Project No.: 17275-1

Re: *Proposed Secondary Plan for Promenade Centre (“the Centre”)*
Promenade Limited Partnership (“PLP”)
Summary of Comments

7411-07
Promenade Shopping Centre –
Master Plan

SUBJECT: REVIEW OF PUBLIC/PRIVATE STREETS AND CORRESPONDING RIGHTS-OF-WAY –
PROMENADE SHOPPING CENTRE, MASTER PLAN

SECTION G -- G
PRIVATE STREETS

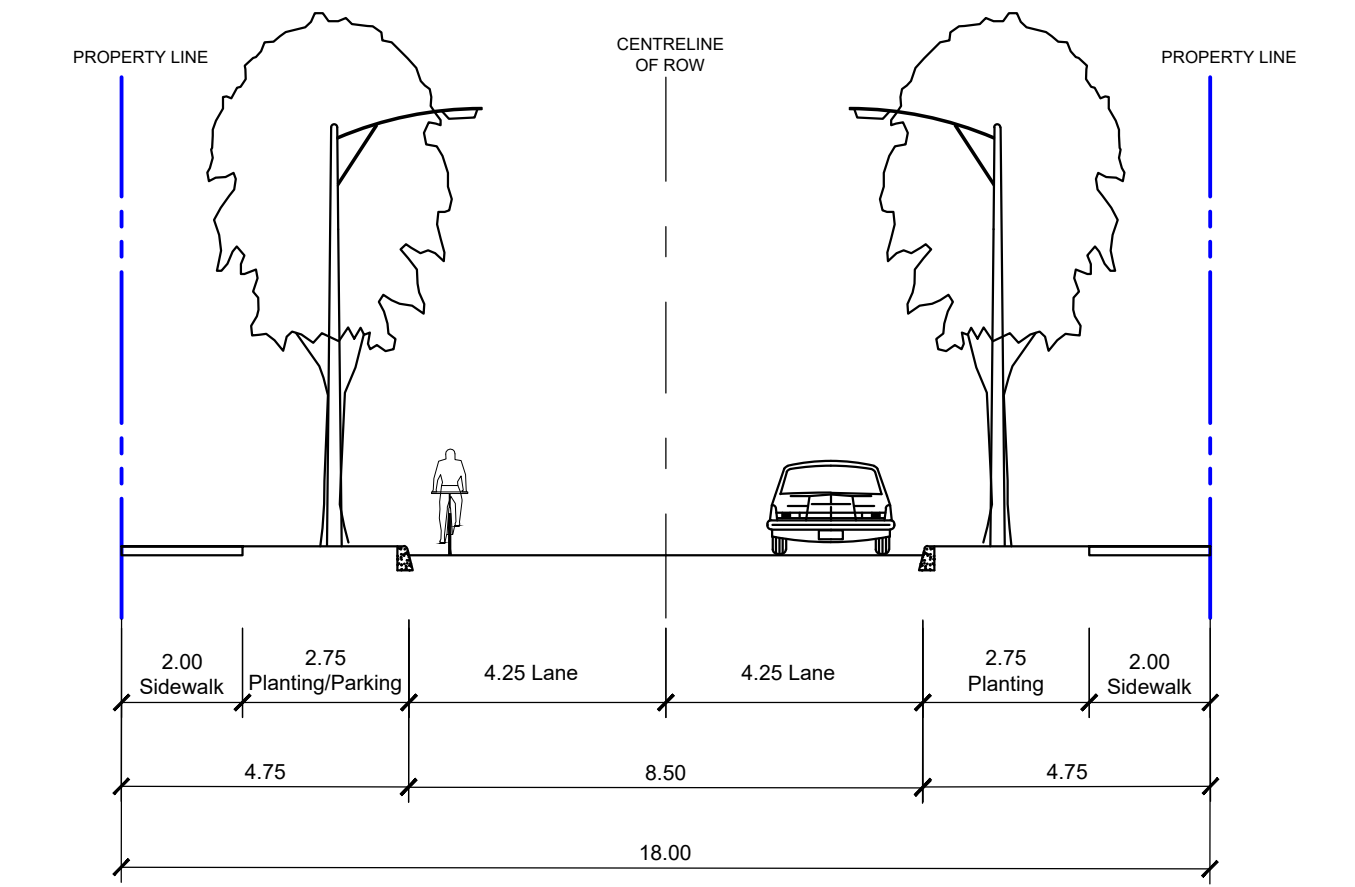
- Ownership: Private Street – PLP Ownership
- ROW: 18 m Right-of-Way
- Posted Speeds: 30 km/h
- Pavement width: 8.5 m pavement width exhibiting a 2-lane cross-section composed two 4.25 m “thru lanes” including Sharrow Lane Markings for shared cycling and motor vehicle use. Alternative Condition: 6.6 m pavement width with added boulevard features.

- **Comments –**
 - The Private 18.0 metre Private Local Streets would provide direct multi-modal access to development parcels including below-grade parking garages, pu/do activities, strategically located on-street parking, and access to existing Promenade Shopping Centre loading areas.

- The 18.0 m ROW would appropriately accommodate emergency service accessibility.
 - Dedicated cycling facilities are not required on every street within the network. The proximity of development intensification on the future PLP development lands relative to the dedicated cycling facilities along all surrounding Public Collector street ROW's and the Path network will appropriately link pedestrian and cycling originating within or travelling through the PLP lands to the broader cycling infrastructure planned for the area, in general.
